From: Laura Ruhl-Whittle <lsruhl@ualr.edu>
Sent: Tuesday, April 5, 2022 3:11 PM
To: Water Draft Permit Comment
Subject: Discharge Permit Number AR0053210, AFIN 60-05010
Attachments: Mill Bayou Letter_Ruhl_Final.pdf; Mill Bayou NPDES comments figures.pdf

Re: *Comments concerning Paradise Valley Wastewater Treatment Plant (NPDES permit # AR0053210) in Roland, Arkansas within the Mill Bayou Watershed.*

Figure 2: Map of the Mill Bayou area with the WWTPs, Outfalls, and Maumelle Water Corp Well locations labeled.

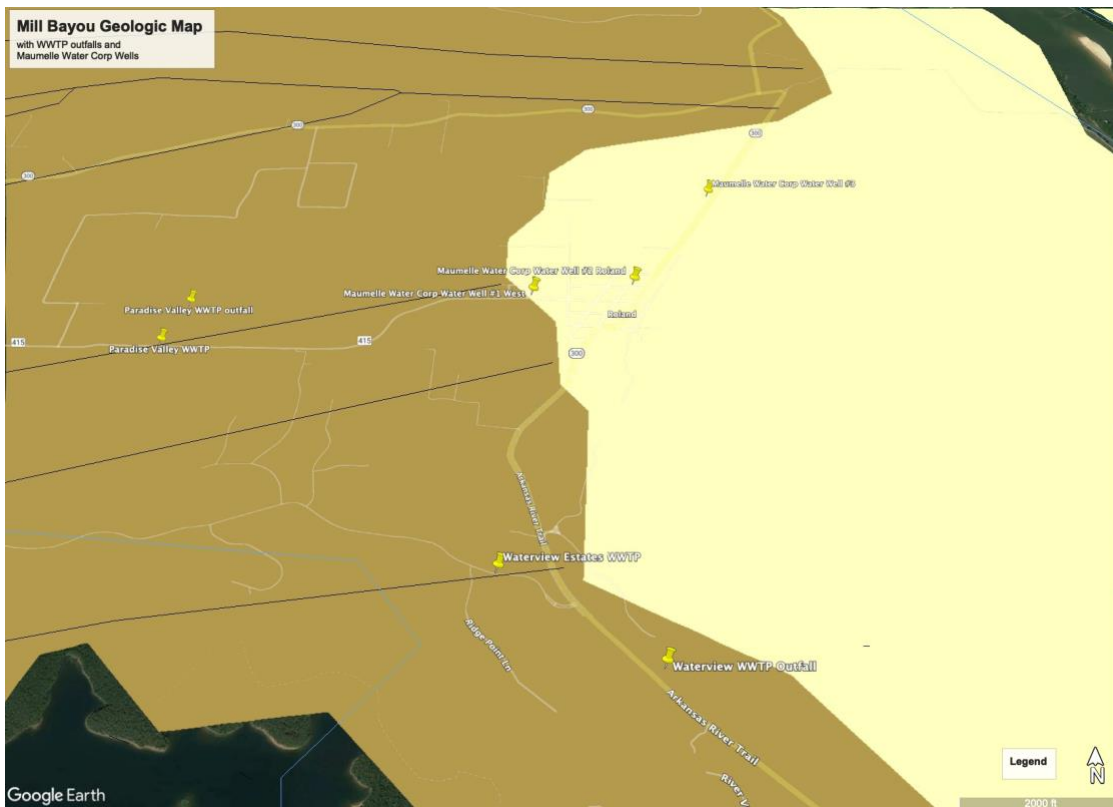
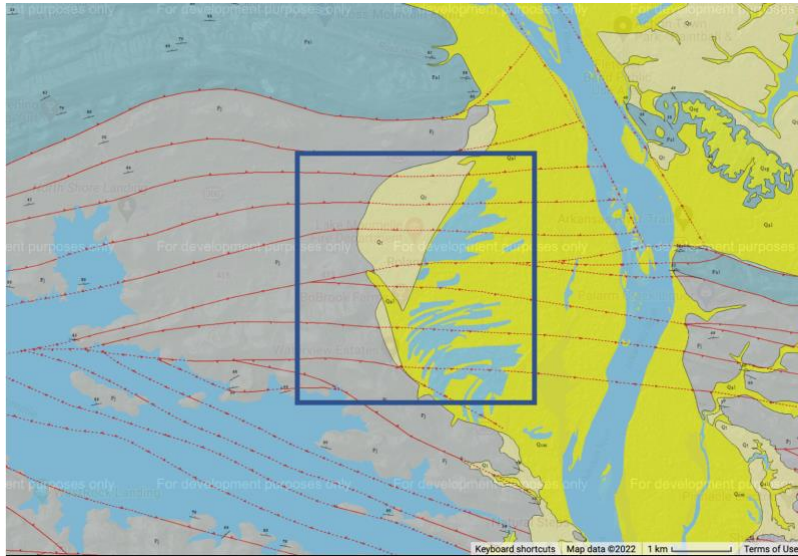
2) **Surfacewater infiltration into groundwater drinking water source:** The town of Roland is dependent on Maumelle Water Corporation for their drinking water, which is supplied from 3 groundwater wells into the Quaternary System Aquifer (Maumelle Water Corp, 2022) (Figure 2). The drinking water source for the Maumelle Water Corporation is the Quaternary Alluvial Aquifer. These geologic units, Qcm, Qal, and Qt (Figure 3), consist of gravel, sand, silt, and clay in channel, floodplain, and terrace deposits. The hydraulic conductivity of these units range from $10^{2.5}$ - $10^{4.5}$ ft/day (gravel) to 10^{-3} to 10^{-7} feet per day (clay) (Heath, 1983) and the deposits can be very heterogenous based on the historic river flow path. Depending on the distribution of the high permeability units like gravel and sand (10^0 to 10^3 feet per day), there is a high probability that the water from the surface will infiltrate into the alluvial aquifer in a fairly short time period. If treated wastewater is discharged to Mill Bayou, where it will have some residence time due to little to now flow, there is a high likelihood that it will infiltrate down to the Quaternary Alluvial Aquifer. While the WWTP outfall is further west and not in the same geologic unit as the groundwater wells, as the water in Mill Bayou makes its way downstream, it will move into the section where it overlies the quaternary alluvial units (Qcm, Qal, and Qt). If it resides in these sections, it will infiltrate into the ground and eventually make its way to the aquifer system. The hydraulic gradient will be from the west to east based on the topographic and hydrologic profiles/gradients of the area. The groundwater will move towards a region with lower hydraulic head like a pumping well or towards the river. Another groundwater source water assessment should be performed with these new facilities (WWTPs) to evaluate the likelihood of treated wastewater infiltrating into the aquifer.

Figure 4: Map of the Mill Bayou Watershed and the FEMA flood hazard zones (source Google Earth and FEMA, 2022).

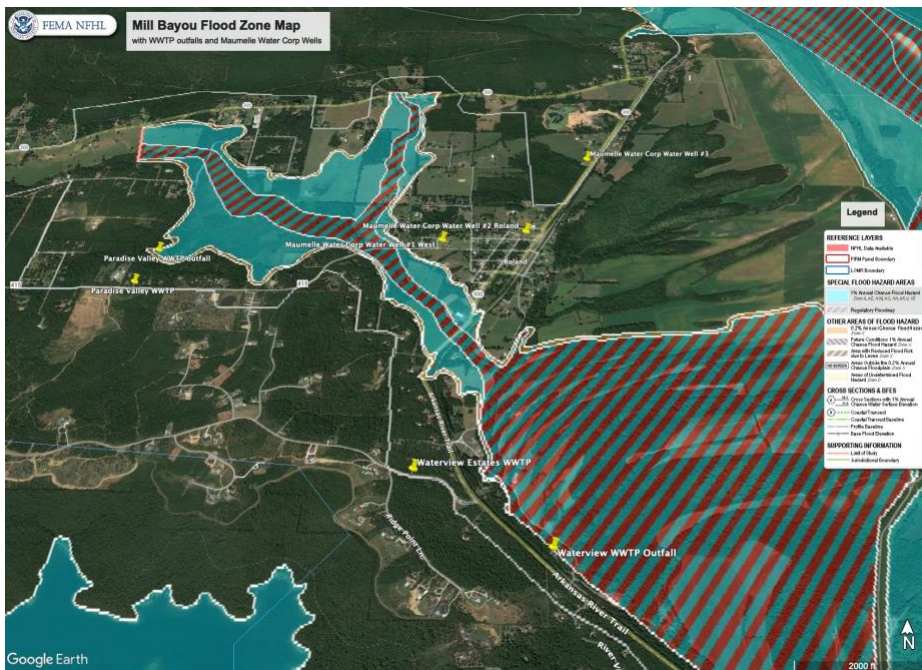
5) **FEMA Flood Zone changes:** The proposed WWTP outfall at Paradise Valley is currently located within a FEMA Flood zone with a 0.2 % annual chance of flooding (orange edge in Figures 4 & 5). Mill Bayou near this location is a wetland with little to no flow (unless there is a precipitation event), and lies

within the FEMA special flood hazard zones (Zone AE). If this WWTP is permitted, I am concerned about the flooding potential in this region. The permit has discharge rates of up to 0.05MGD (critical % flow is 0.04MGD or 40,000 gallons per day; 80 %) of treated wastewater into a tributary in the upper portion of the Mill Bayou Watershed. I am concerned that the additional water within this portion of the watershed will alter the current flood hazard zones, and therefore a re-evaluation of the flood zones should take place.

Additionally, if this WWTP is installed it will be the second within this small watershed. The other outfall is NPDES permit #AR0050393 located downstream in the watershed. The amount of wastewater from the 2 outfalls within the 10mi^2 watershed is concerning especially since there is little to no flow in these streams, therefore most of the water within the streams would consist of treated wastewater. Depending on the Arkansas River levels and the surrounding flat topography, this could result in backing up of water in the watershed and additional flooding of the surrounding lands.

This permit (#AR0053210) for an additional wastewater treatment plan in the Mill Bayou Watershed is of serious concern for flooding, surface water, and groundwater issues. I strongly recommend re-evaluating the FEMA flood hazard zones if 0.05MGD could be released. Additionally, another source water assessment should be performed to evaluate whether treated wastewater could make its way to the Alluvial Aquifer System that provides drinking water to the Roland community.
